NIAGARA MOHAWK POWER CORPORATION

DOCKET NO. 50-410

Proposed Changes to Technical Specifications

Supporting Information and No Significant Hazards Consideration Analysis

FIGURE 3.3.2-1 Allowable and Trip Setpoint Values for the Main Steam Line Tunnel Lead Enclosure

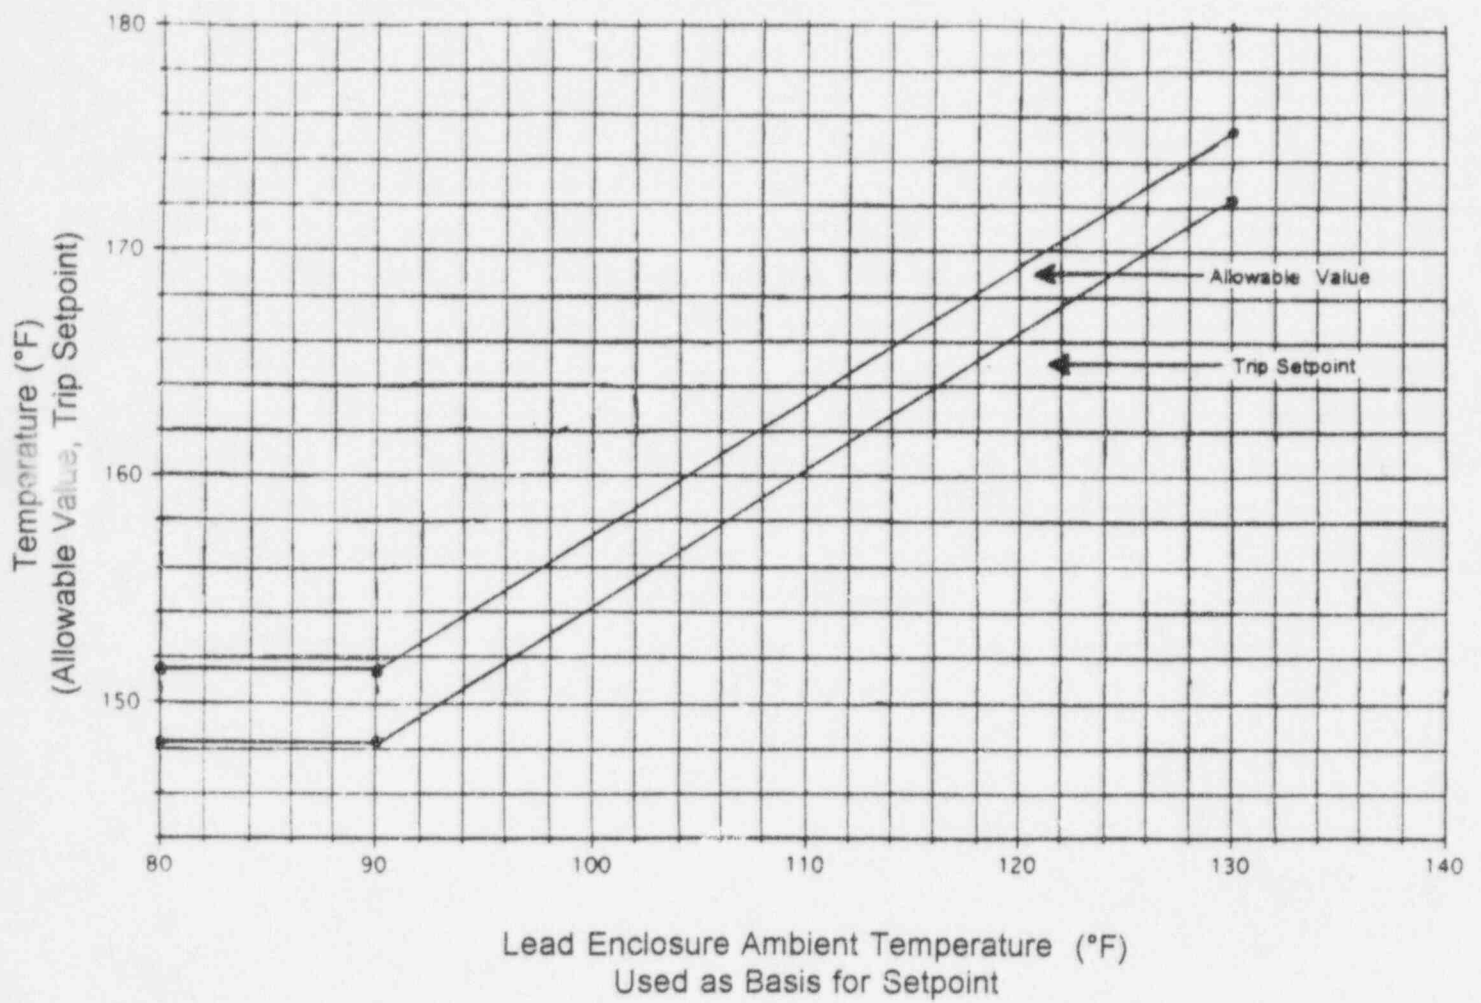
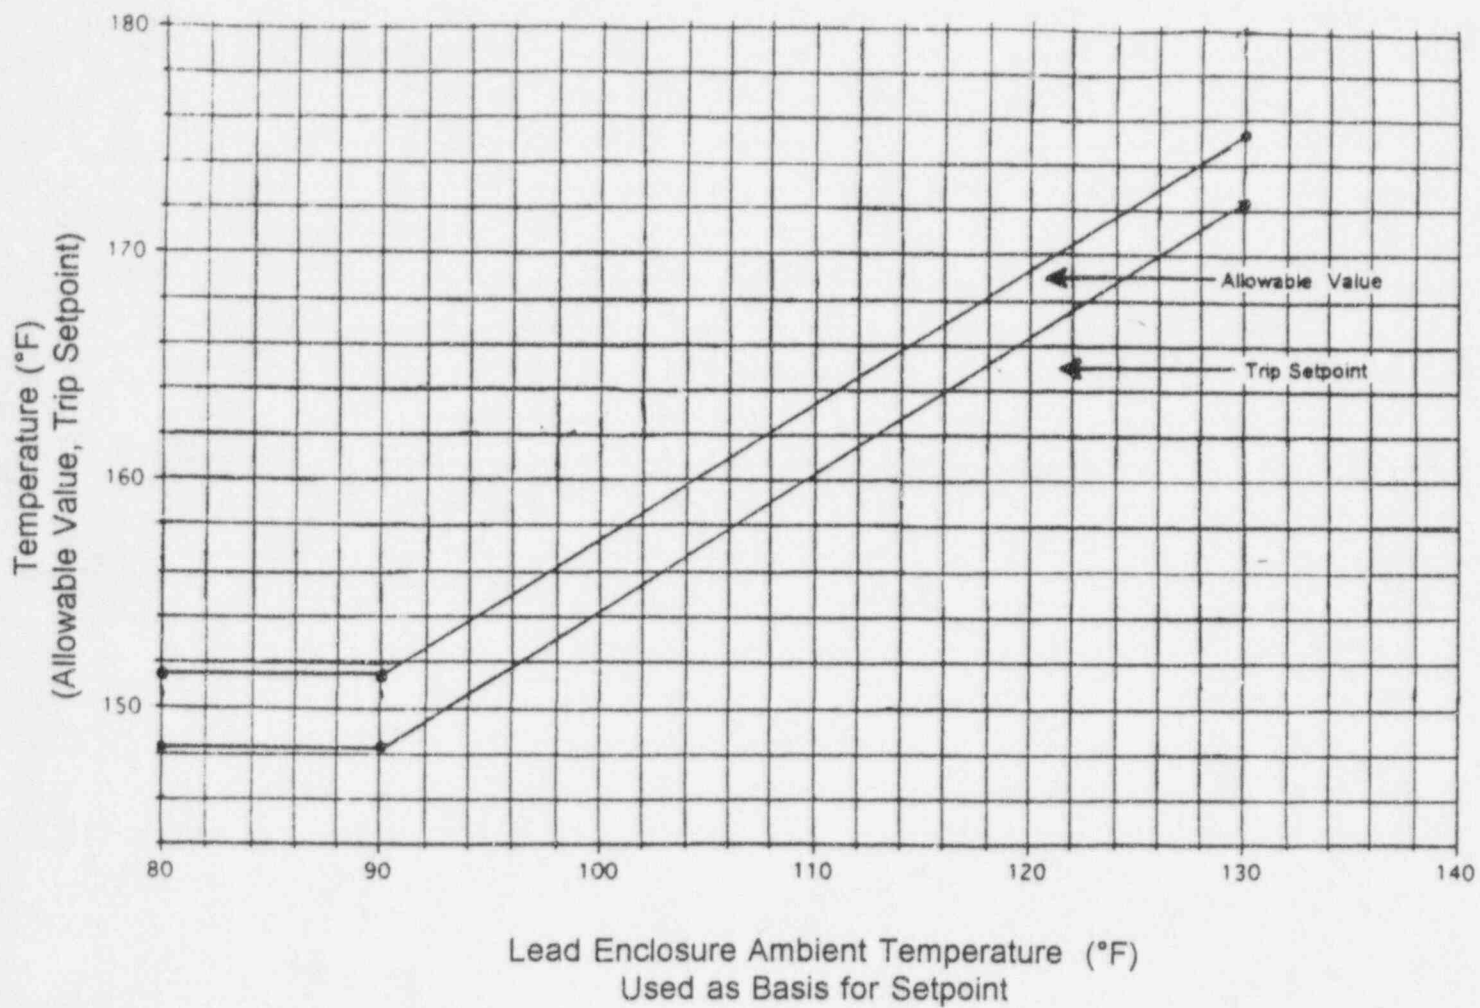
Replace existing pages v, 3/4 3-17, 3/4 3-19A, 3/4 3-25, and 3/4 3-28 with the attached revised pages. These pages have been retyped in their entirety with marginal markings to indicate changes to the text. Also, add page 3/4 3-19B, which contains Figure 3.3.2-1, "Allowable and Trip Setpoint Values for the Main Steam Line Tunnel Lead Enclosure."

- *** The trip setpoint and allowable value for a channel may be established based on Figure 3.3.2-1, if:
- a. the actual ambient temperature reading for all operable channels in the Lead Enclosure area are equal to or greater than the ambient temperature used as the basis for the setpoint, and

- *** The trip setpoint and allowable value for a channel may be established based on Figure 3.3.2-1, if:
- the actual ambient temperature readings for all operable channels in the Lead Enclosure Area are equal to or greater than the ambient temperature used as the basis for the setpoint, and

Niagara Mohawk Power Corporation (NMPC) has determined that the temperatures in the Main Steam Line Tunnel Lead Enclosure resulting from a postulated steam leak are dependent on the initial ambient temperature in the area. The acceptable trip setpoint and allowable temperatures, based on initial ambient temperatures, have been calculated and

plotted on proposed Figure 3.3.2-1. The range of temperatures for the allowable value and trip setpoint for main steam line isolation are the result of calculating the temperature increase for a main steam line leak for a range of initial temperatures. Since these calculated values are based on normal operating conditions, the absence of any steam leaks in the Main Steam Line Tunnel Lead Enclosure area is required to be visually verified prior to increasing the setpoint of any temperature instrument channel. Furthermore, a new surveillance requirement has been established to verify the continued validity of a setpoint established using Figure 3.3.2-1. The surveillance involves confirming, once per shift, that the actual temperature reading for all operable temperature channels in the Lead Enclosure area are equal to or greater than the ambient temperature used as the basis for the setpoint. This change does not affect the setpoint, function, or operation of the temperature instruments in the main steam line tunnel which are not in the Lead Enclosure area.

A small steam leak in the Lead Enclosure area could increase the ambient temperature in the area without causing a main steam line isolation. Raising the trip setpoint based on an ambient temperature affected by a steam leak could compromise the ability to detect a leak of 25 gpm. Therefore, a requirement to confirm the absence of steam leaks in the Lead Enclosure area, before increasing the setpoint of any temperature instrument channel, has been incorporated into this proposed TS change.

- b. the absence of steam leaks in the Main Steam Line Tunnel Lead Enclosure area is verified by visual inspection prior to increasing a channel setpoint, and

- c. a surveillance is implemented in accordance with Note "d" of Table 4.3.2.1-1.

- (d) In addition to the normal shift channel check, if a channel setpoint has been established using Figure 3.3.2-1, then once per shift the actual ambient temperature reading for all operable channels in the Lead Enclosure area shall be verified to be equal to or greater than the ambient temperature used as the basis for the setpoint.

The LDS instrumentation in the main steam line tunnel isolates the Main Steam Isolation Valves upon sensing a steam leak of 25 gpm. For an elevated ambient temperature in the Lead Enclosure area, a setpoint established using the proposed Figure 3.3.2-1 ensures that the Main Steam Isolation Valves continue to receive an isolation signal upon sensing a steam leak of 25 gpm. Verifying the absence of any steam leak in the area prior to raising any temperature instrument setpoint ensures that the ability to sense a 25 gpm leak is not compromised by an increased ambient temperature resulting from a smaller steam leak. The periodic surveillance to verify the actual ambient temperature ensures the continued validity of the ambient temperature used for the setpoint basis, and provides sufficient advance indication to take appropriate compensatory action. Accordingly, this change will not involve a significant increase in the consequences of any accident previously evaluated.
